Product Change Notice

Product Type: 60#80# Servo Motor

200W, 400W, 600W, 750W, 1000W

(Figure 1)

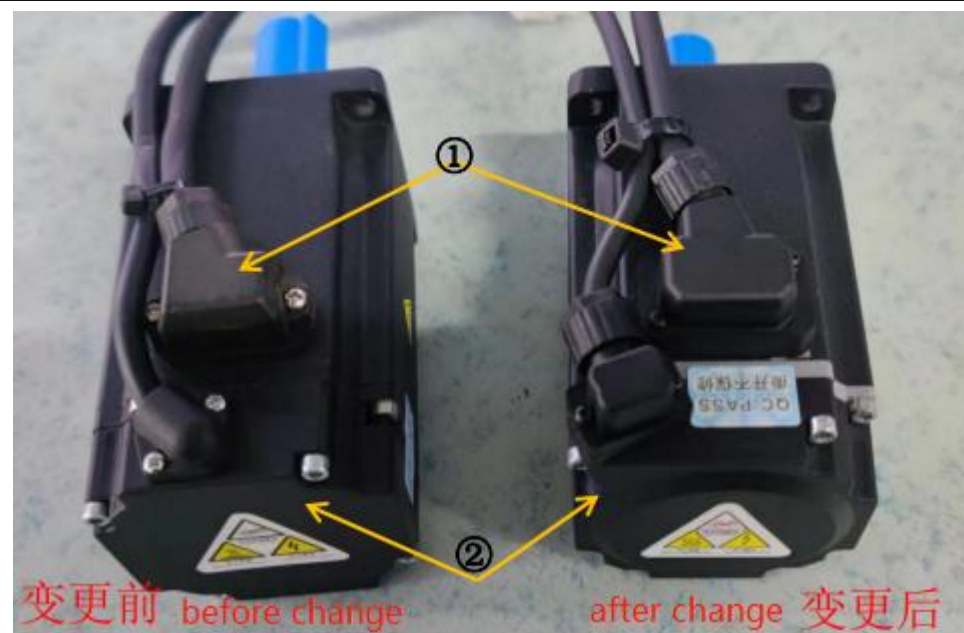
1. Adjusted the structural shape of the outlet parts (the schematic diagram before and after the installation of the connector version of the motor harness, see the attached picture 1).
2. The appearance of the motor has been adjusted, see attachment picture 2.
3. The length of the model without brakes is the same as that of the original product, and the length of the model with brakes has been adjusted (the length of the 60 brake model is shortened by 11mm. The length of the 80 brake model is shortened by 5mm). See the attached picture 3.
4. For the magnetic motor with brake, the magnet in the encoder magnetic holder is changed from $\phi 13$ to $\phi 20$ mm.
